Docket No. 410

REVIEW COMMENTS ON NINE MILE POINT UNIT 2 EMERGENCY PLAN

The following comments apply to the Nine Mile Point Unit 2 Emergency Plan (hereinafter called the plan), and identify in parentheses the applicable evaluation criteria of NUREG-0654/FEMA-REP-1, Rev. 1 (Regulatory Guide 1.101 Revision 2).

FLOW CHART FOR GENERAL EMERGENCY OFFSITE PROTECTIVE DECISIONS

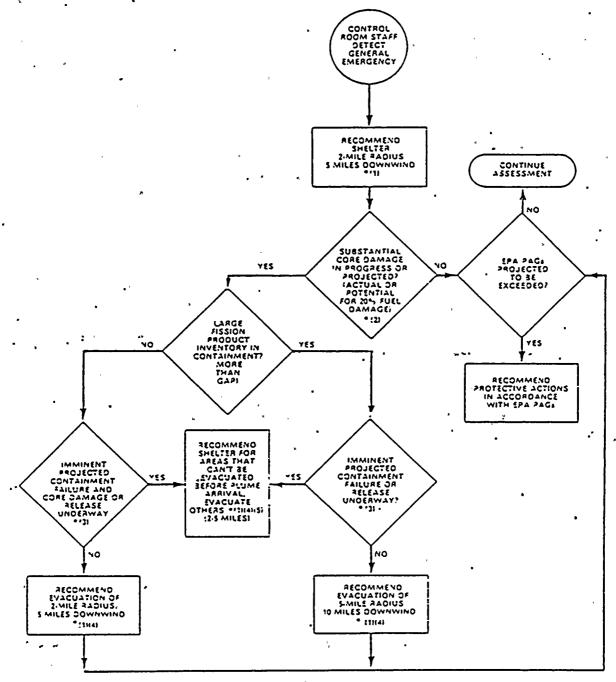
<u>Initiating Conditions 1, 2, 3, 4, 6, & 7</u> The applicant does not have adequate EALs for any of the applicable NUREG-0654, Appendix 1 General Emergency Initiating Conditions. It is suggested that the applicant refer to the flowchart in Attachment 1 for guidance in developing appropriate protective action decisions.
